## ANN ARBOR HISTORIC DISTRICT COMMISSION

### Staff Report

**ADDRESS:** 517 East Washington Ave. (512 E Huron Street), Application Number  
HDC 13-093

**REPORT DATE:** July 5, 2013

HURON STREET ENTRY  
 SCALE: 1/8" = 1'-0"

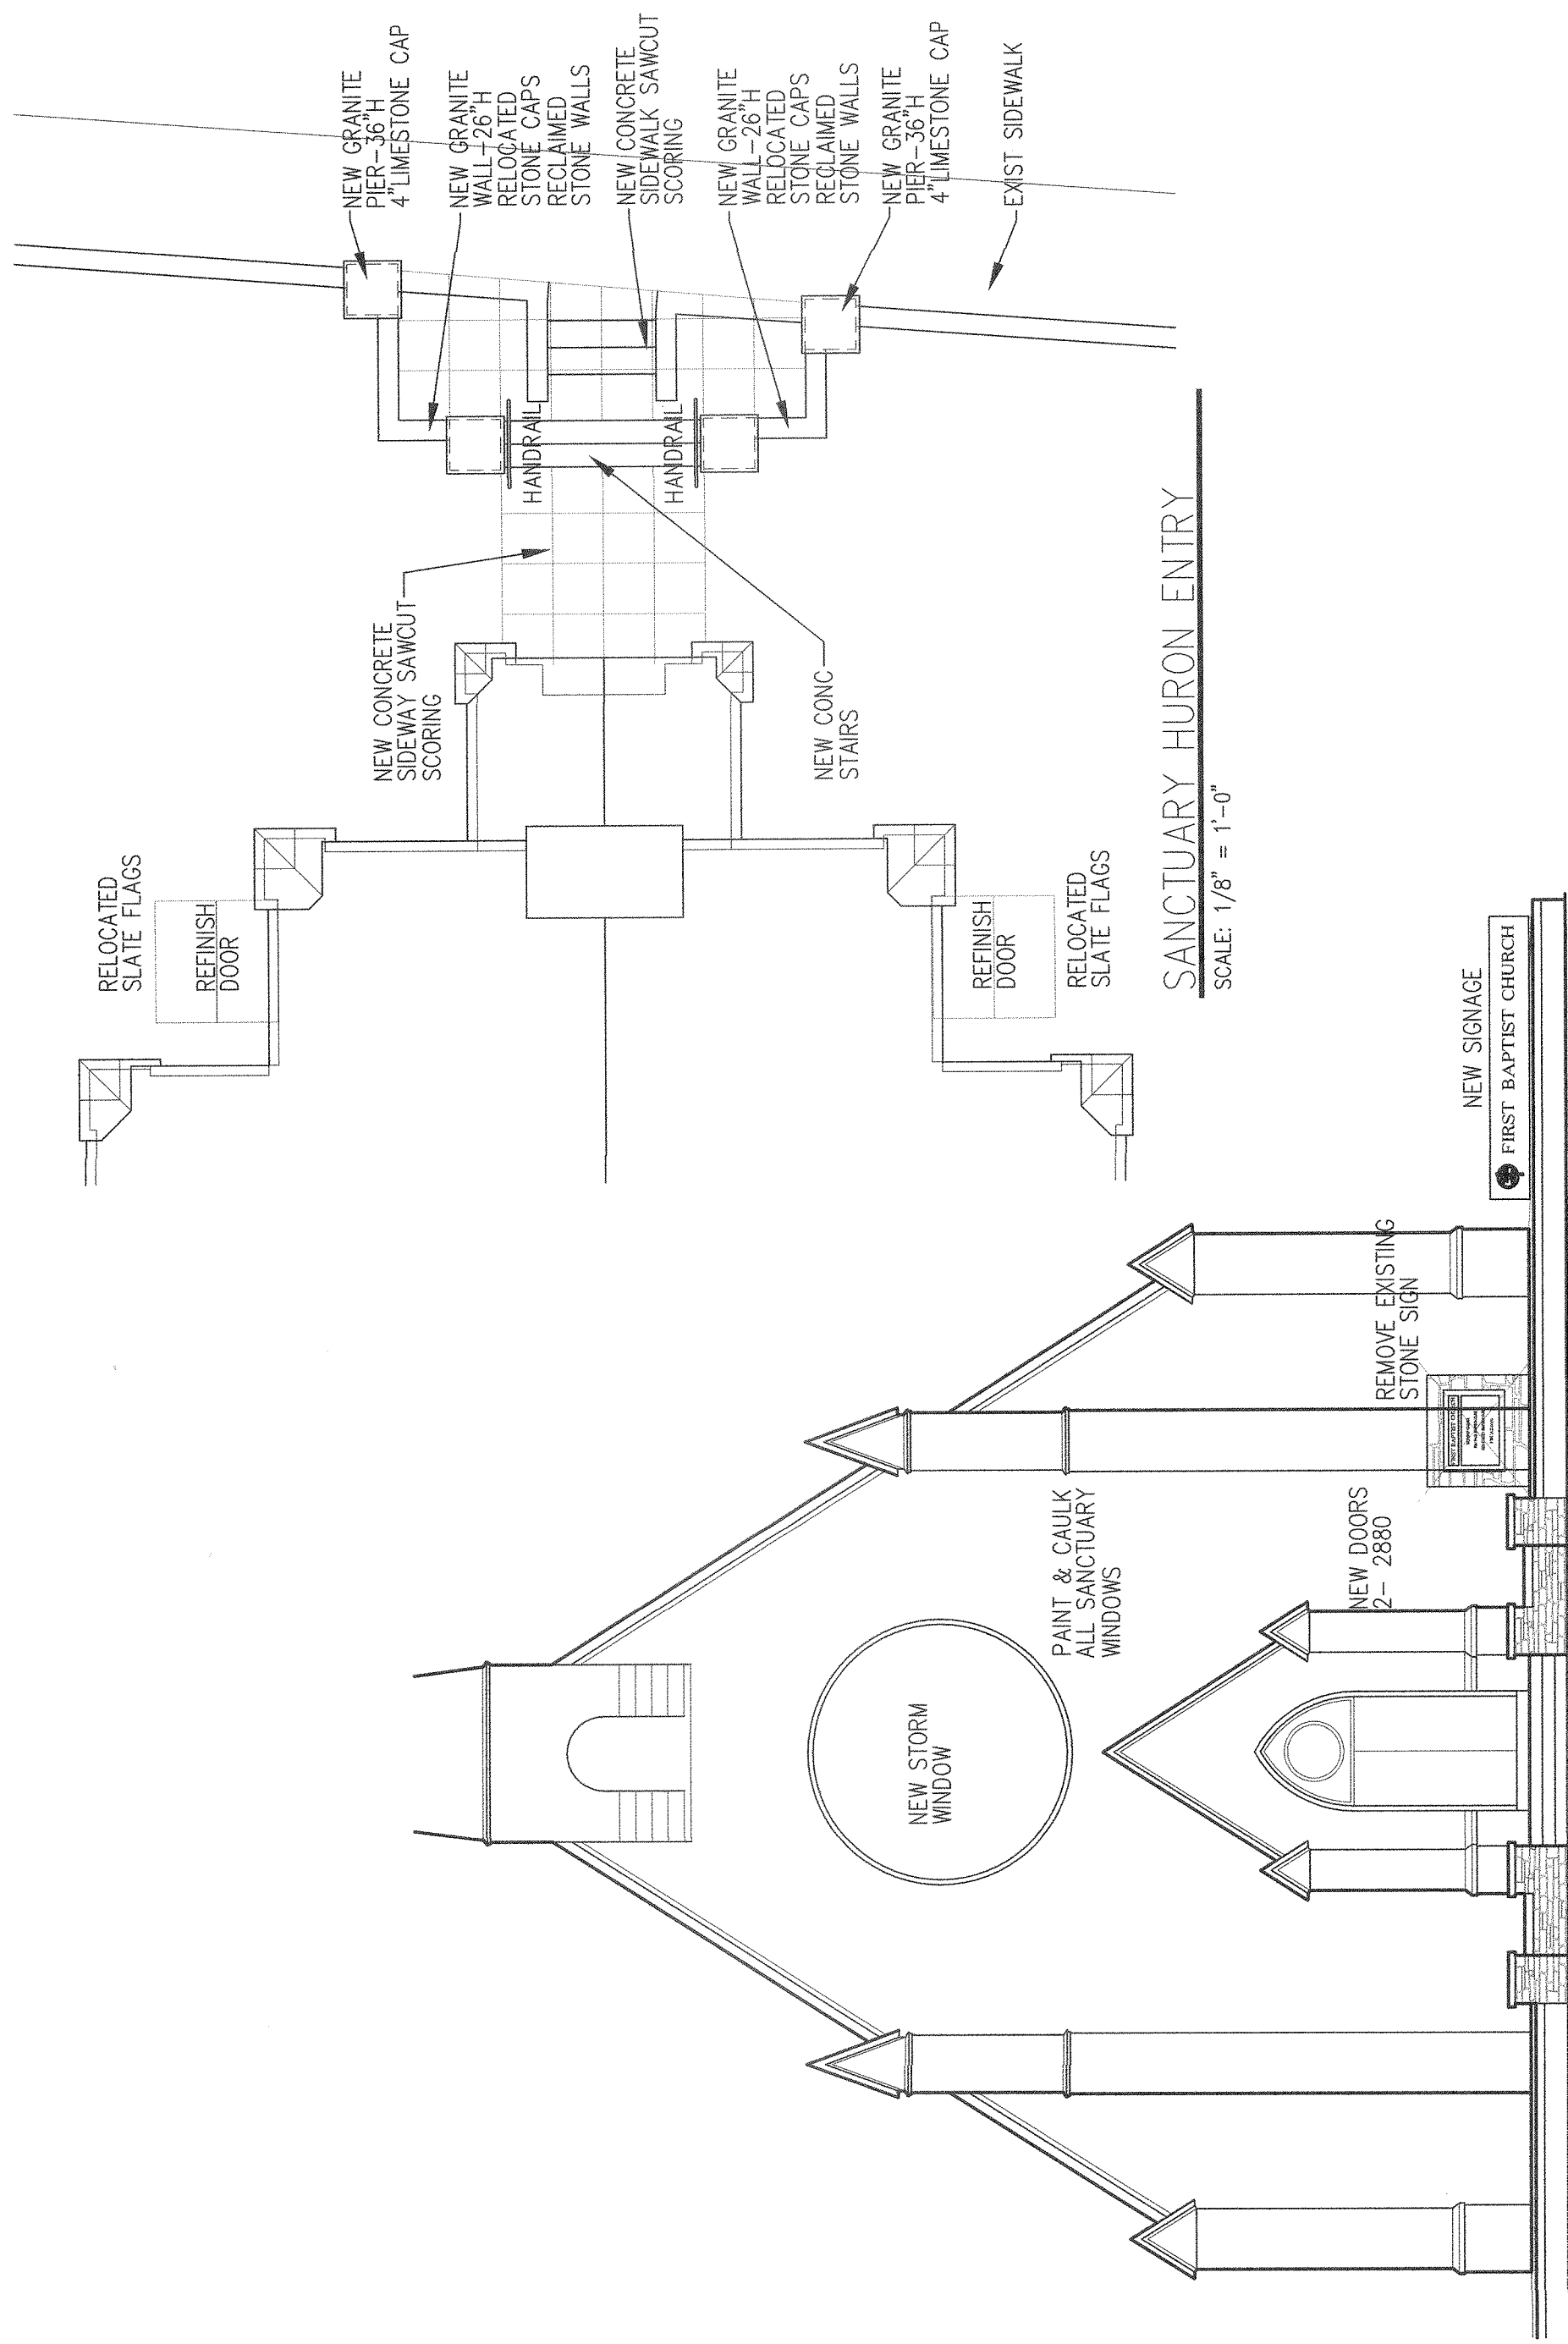
4. The existing front entrance consists of a low granite retaining wall, with a short set of concrete stairs and simple metal handrail leading to the entrance of the sanctuary. Based on the photograph from the late 1800s, the retaining wall appears to have changed very little since then, and the applicant states that the retaining wall and slate sidewalk are original. The set of stairs and handrail both appear to be more recent additions. The slate would be relocated to landing areas outside of the emergency doors on the east and west elevations near East Huron.

5. The proposed changes include reconstructing the retaining wall around the staircase by widening the landing at the foot of the stairs, and inseting it from the sidewalk. This will involve removing several portions of the original retaining wall. The applicant states that the stone and cap removed from the retaining wall will be incorporated into the new configuration. The new configuration will include constructing four piers with granite caps

that will be 36-inches tall, separated by lower sections of granite retaining wall that are 26-inches tall. The remaining portions of the original retaining wall will be repaired as necessary. Staff believes that changes to East Huron Street (mainly widening) warrants the alteration of the original wall to allow a small gathering space off of the city sidewalk.

6. The applicant also seeks to replace the existing concrete stairs and sidewalk. The new stairs will also be concrete, and will be wider than the existing stairs. A simple handrail will be added to each side of the new stairs. The sidewalk leading to the Sanctuary entrance will be replaced with a new concrete sidewalk.

SITE PLAN  
 SCALE: 1/32" = 1'-0"

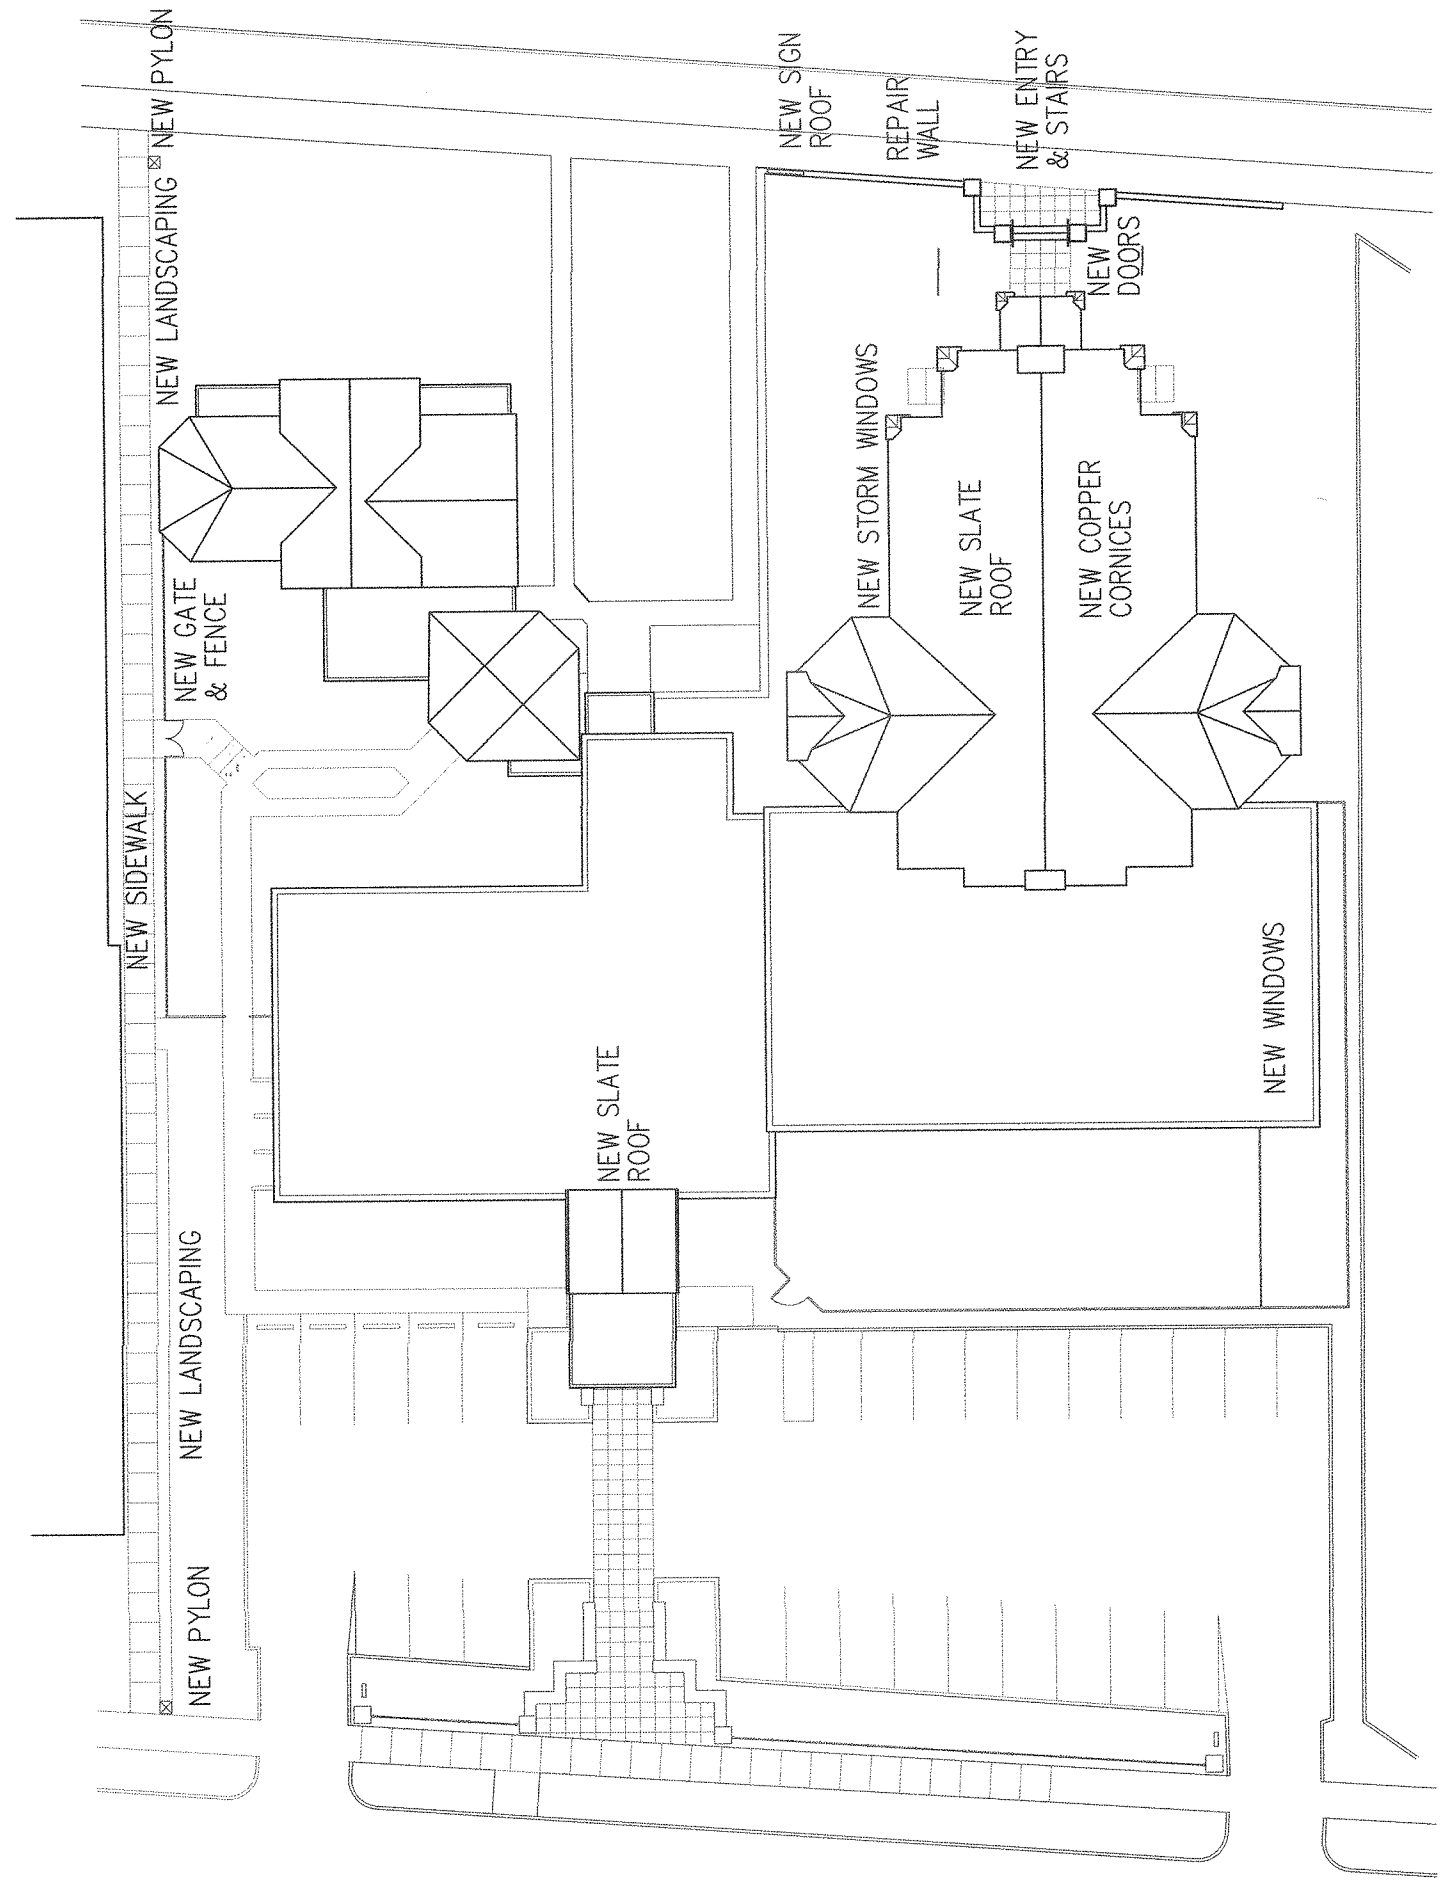
9. The applicant also proposes installing a new sidewalk, pylons, and fencing along the west lot line between the church and the Landmark high-rise development immediately to the west. The sidewalk would be 5' wide and concrete. The black metal fencing would match the one along the parking lot off East Washington Street, and detail for the ornate metal gate into the garden behind the Silas Douglass house is included with the application. The pylons are 6' tall, and faced in split-faced fieldstone with a limestone cap. They are intended to mark the location of the publicly-accessible sidewalk running from East Huron to East Washington between the two sites.
